A1 Birtley to Coal House

Applicant's Responses to ExA's Second Written Questions - Appendix 2.0F - Structure Options Report 2 - Allerdene Culvert

STRUCTURE OPTION REPORT 2 ALLERDENE CULVERT

Safety Engineering & Standards (SES) Record Sheet					
Scheme Name:	A1 Birtley to Coalhouse	<u>Comments Sheet Document Control</u>			
		Comment sheet version	Date HA comment sheet	Date Designer's reply sent	Notes
Document Ref	HA551462-WSP-SBR-MN001-RP-CB-0001	A	05/03/2018	16.03.2018	
		B	20/03/2018		
SOR version	Structure Option Report Allerdene Culvert	C	04/10/2018	21/11/2018 Further responses 19-02-19	
		D			
AIP Date	-	E

OPTION C: STEEL CORRUGATED ARCH

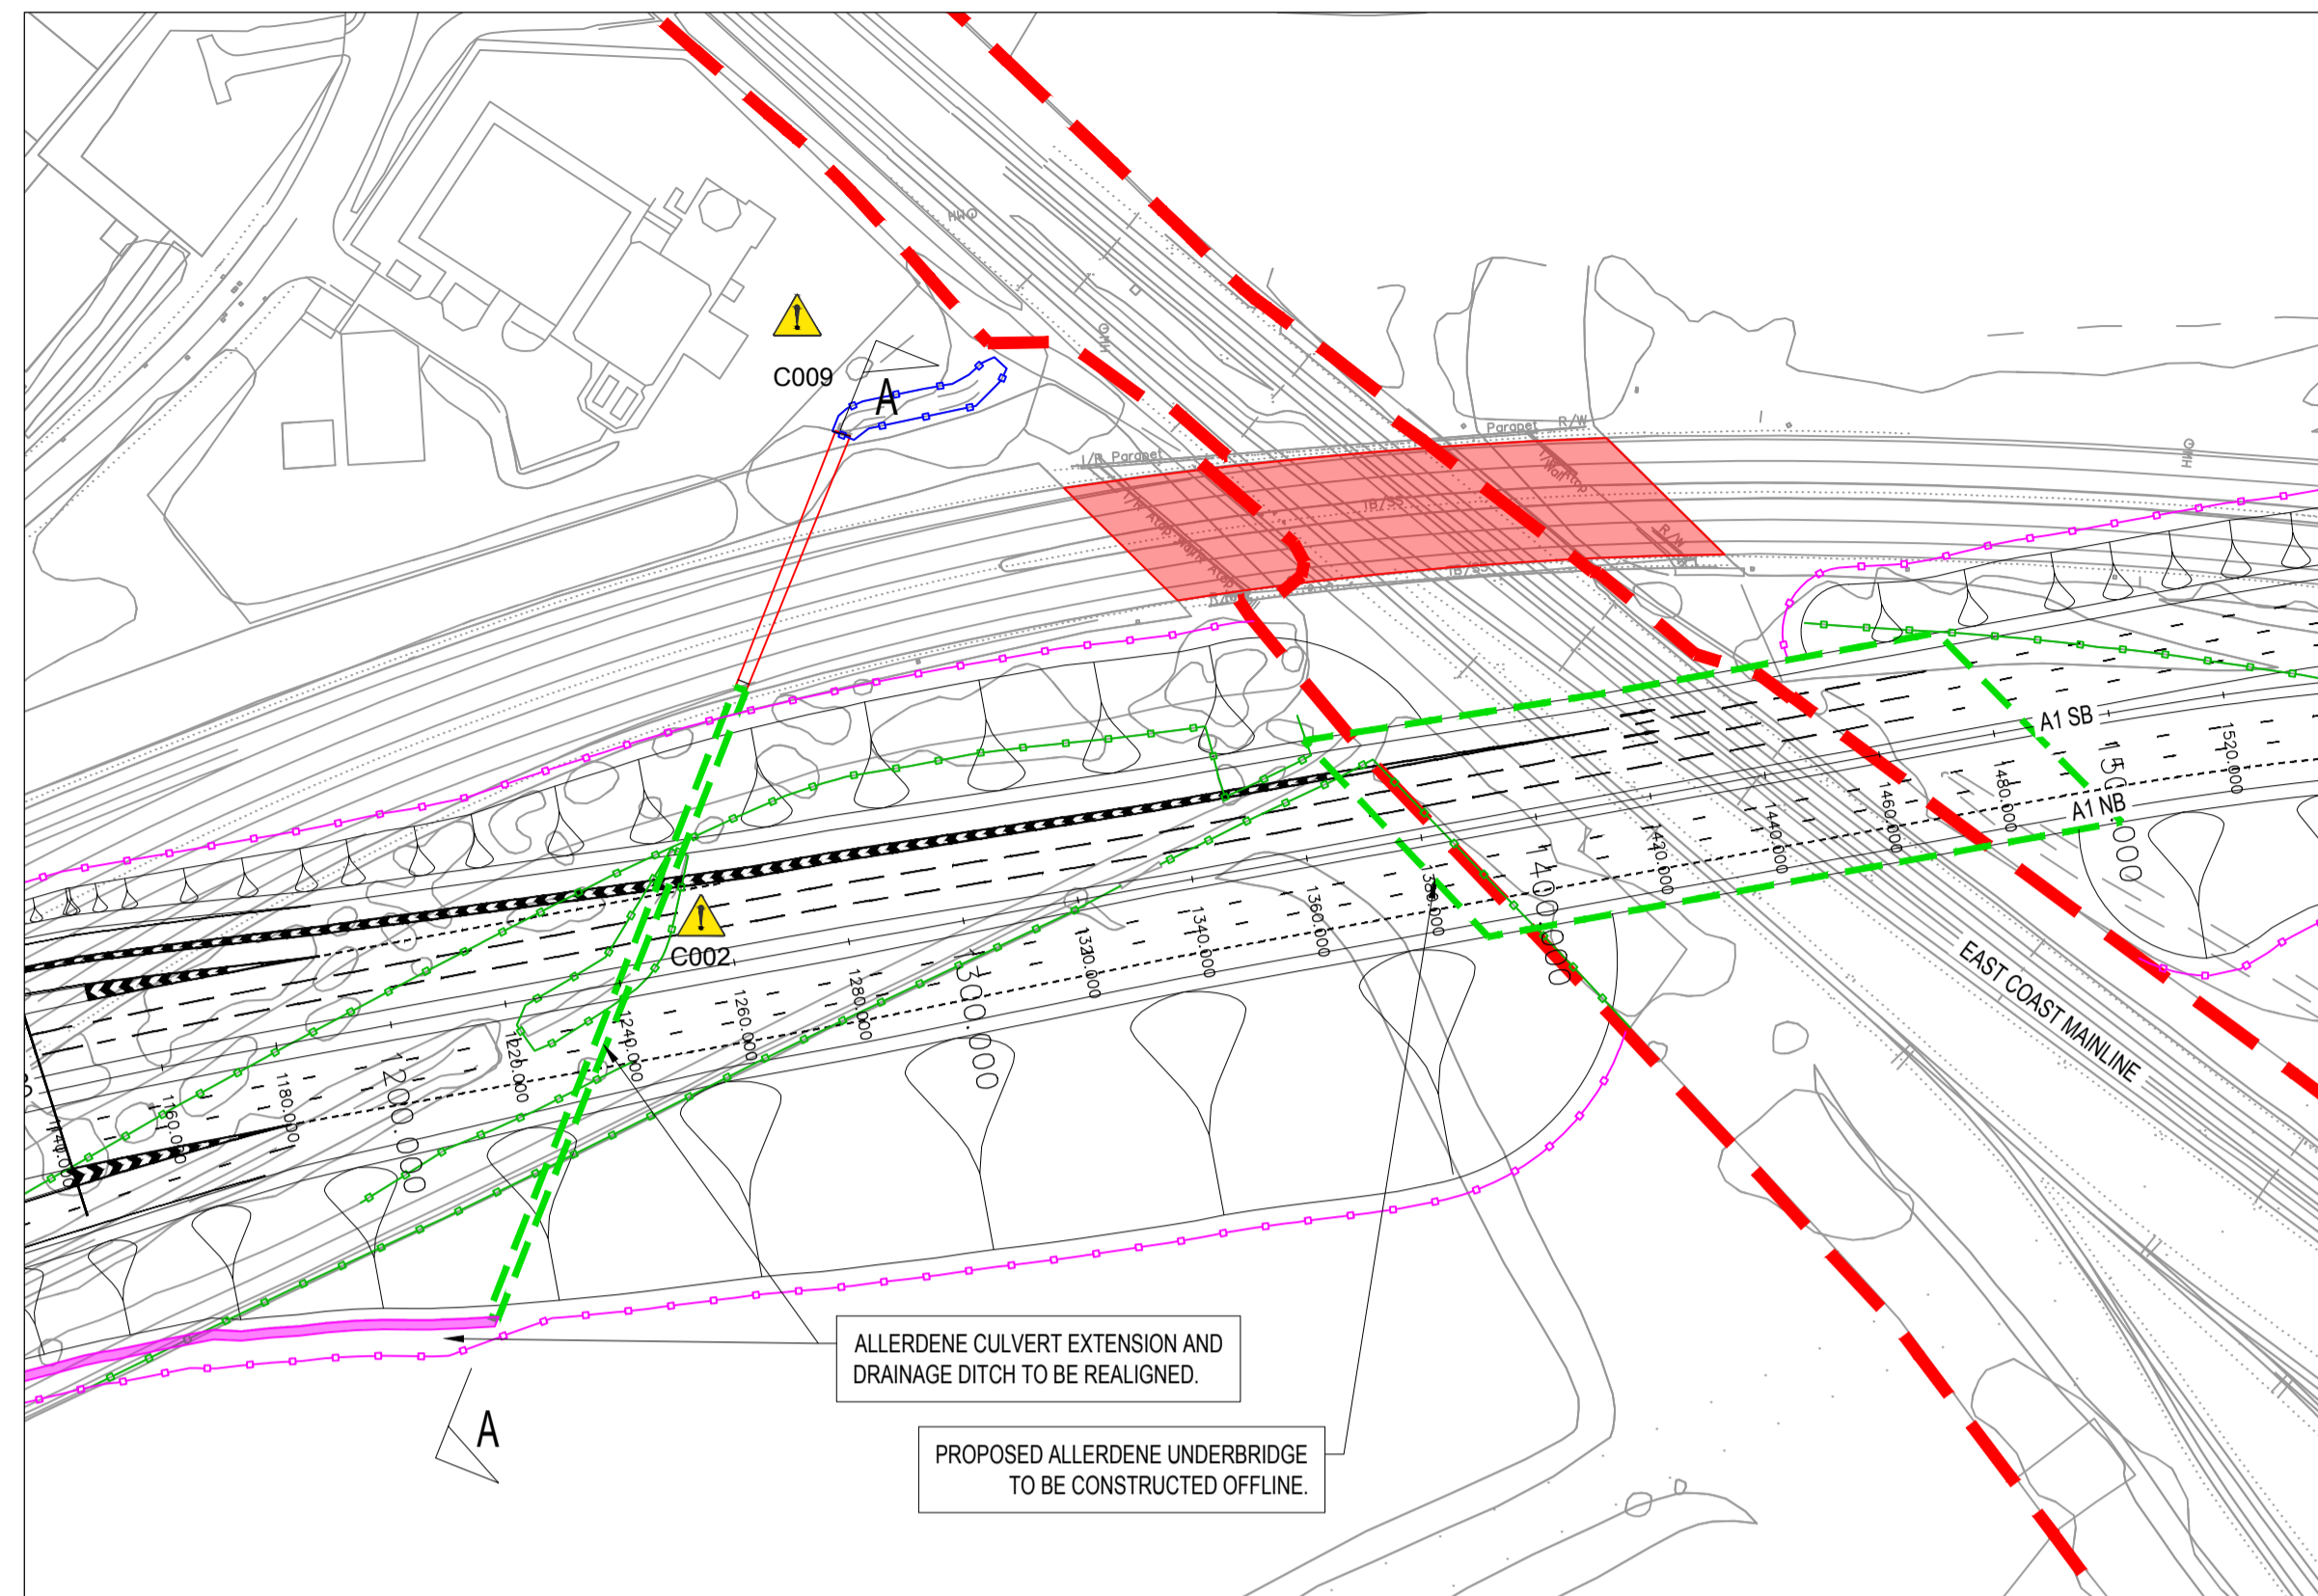
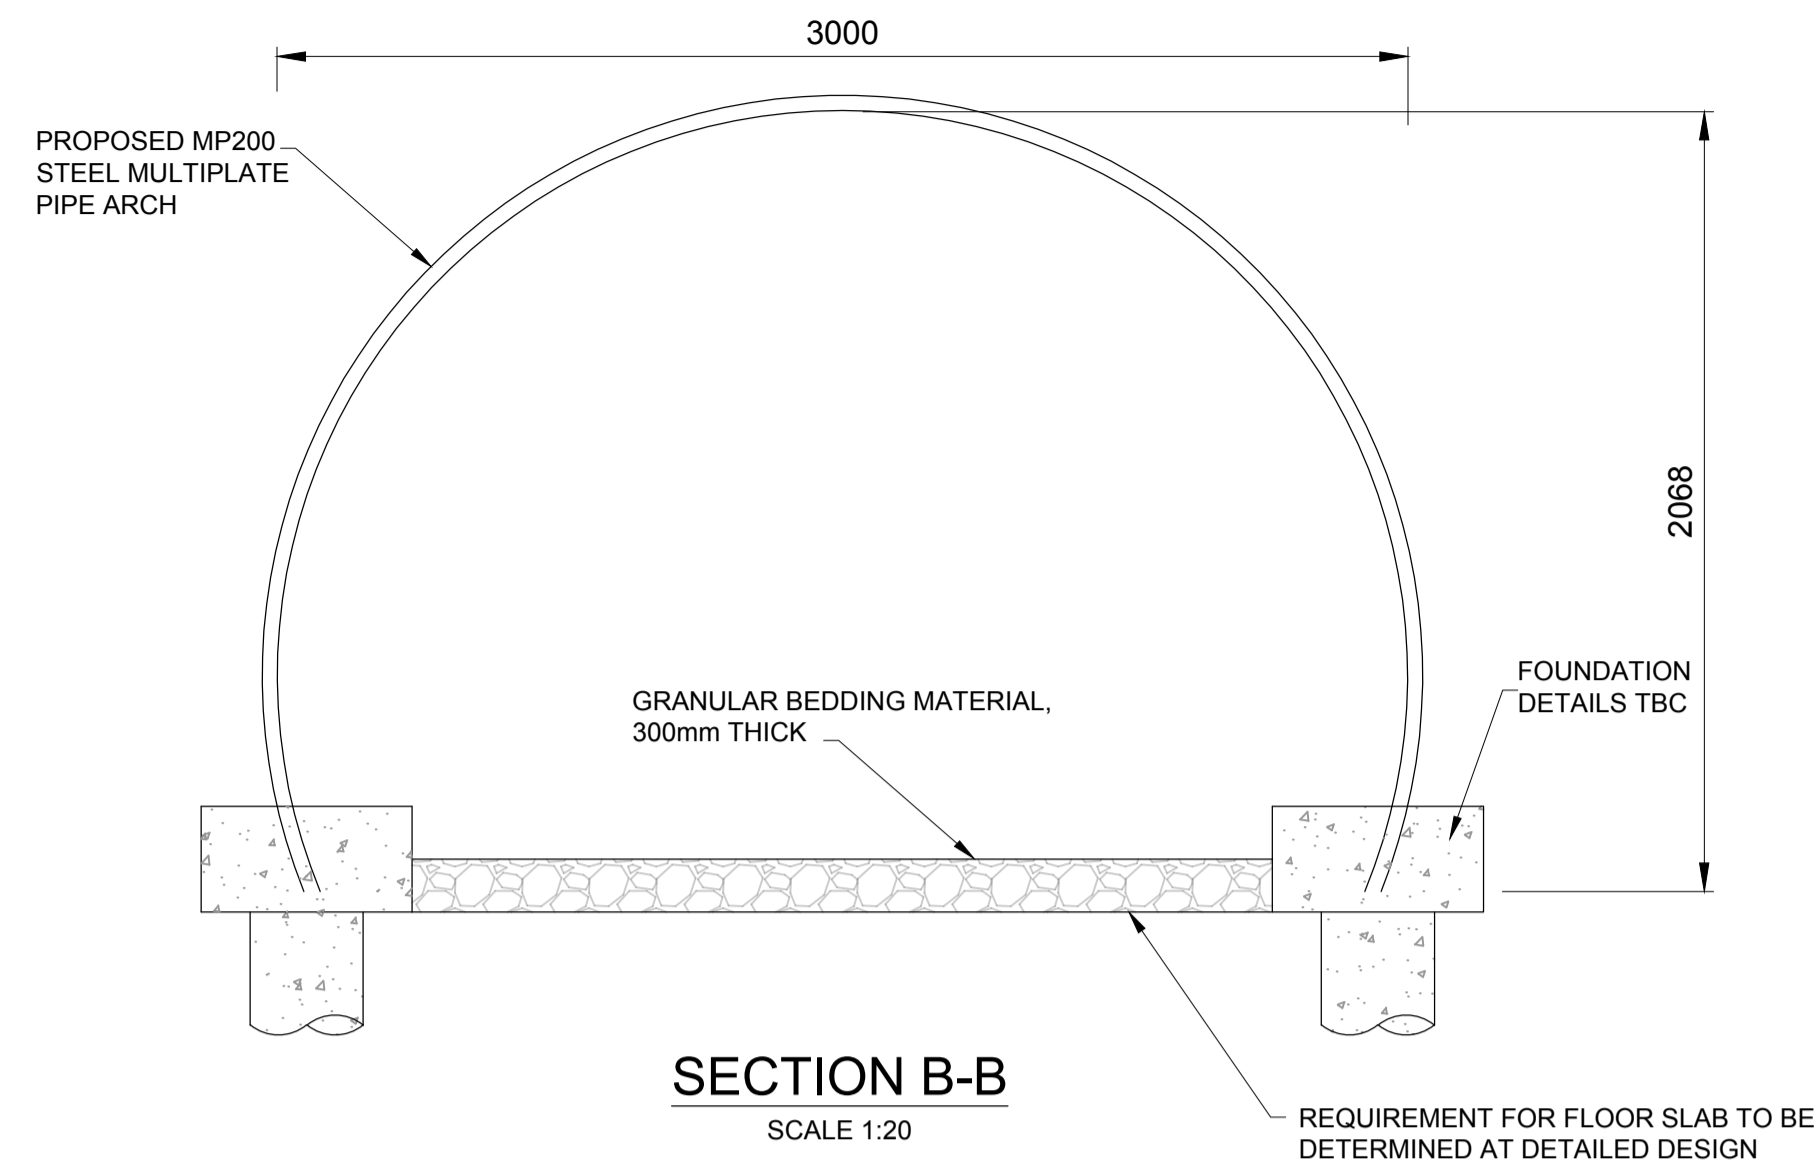
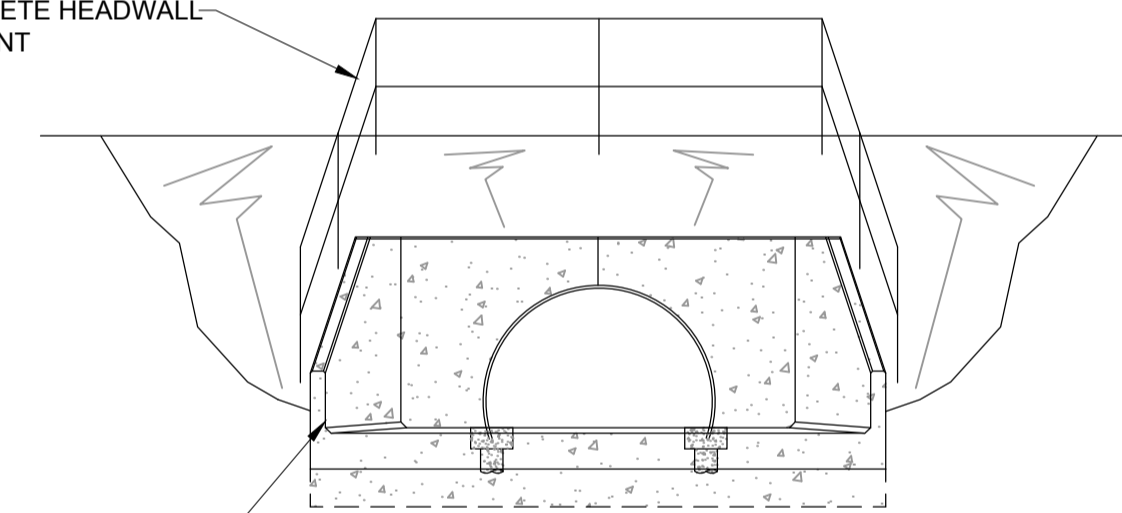
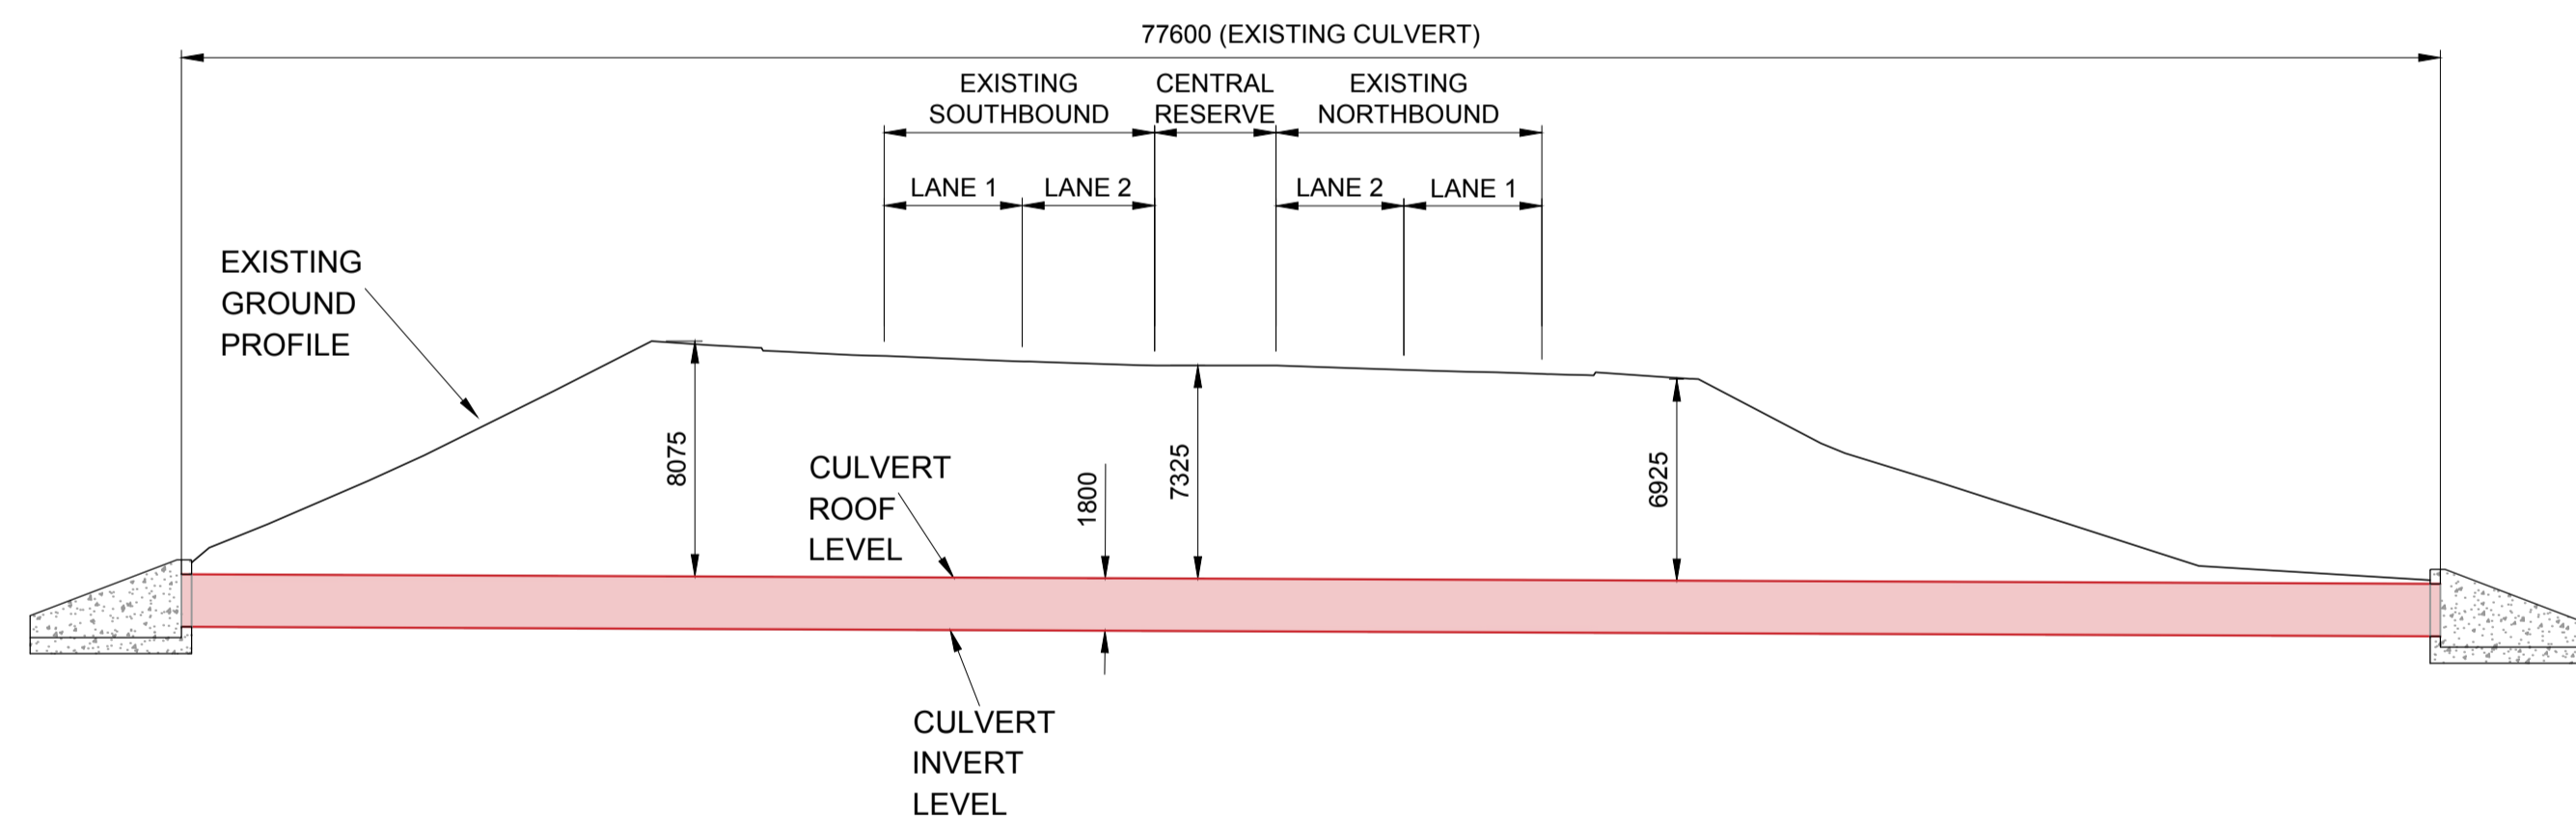
11	3.4 & 4.4.2	Please explain why preliminary proposal for Option C requires piled foundation and for option A does not? See also comment to Option C drawing – floor slab is required there that is currently missing.	<p>Piles were selected for Option C (corrugated arch) to minimise settlement of the pilecap and also sustain the horizontal thrust imposed by the arch superstructure.</p> <p>Floor slab shall be shown on the drawing for option C. 19-02-19 Reference to the requirement for a floor slab (subject to detailed design) provided on the Option C GA</p>	20/03/2018 Please see further comment to 17
		Floor slab not shown. The granular bedding material will not perform well in case of settlement or heave caused by adjacent abutment's settlement. Horizontal thrust from arch will result in laterally loaded piles i.e. large diameter required.	19-02-19 Reference to the requirement for a floor slab (subject to detailed design) provided on the Option C GA

Floor slab not shown – see further comment 11 above.	Refer to comment 11 response. 19-02-19 Reference to the requirement for a floor slab (subject to detailed design) provided on the Option C GA	
18	Designer's Risk Assessment	004 – this should be either type S or P temporary works (please state which type) and in both cases the PW Designer needs to endorse the TW design with regards to the permanent structure. Contractor appears not to be the owner here. Please consider amending.	Noted, shall be amended/reworded.	See below.
		Not amended/ reworded.	DRA shall be amended to address comment. 19-02-19 Reference to the requirement for type P and S temp work design in accordance with BD2/12 has been highlighted on the DRA	
19	Designer's Risk Assessment	005 – the weight of the structure itself is of little relevance to the overall settlement. It's rather the combined weight of the proposed embankment over the area that was not subject to surcharge load that might cause the problem, especially giving the alluvium deposits. When recommending design action (piled foundation) – was consideration given to the negative skin friction and extra load imposed onto the structure and foundation due to settlement of the	Noted, to be amended/reworded. Refer to response to comments 4 & 5.	See below.

33	4.4.2	<p>Lack of slab means piles are loaded horizontally due to thrust from the arch. Why slab is not provided as already discussed above?</p>	<p>GA drawing will be amended to show floor slab.</p> <p>19-02-19 Reference to the requirement for a floor slab (subject to detailed design) provided on the Option C GA</p>
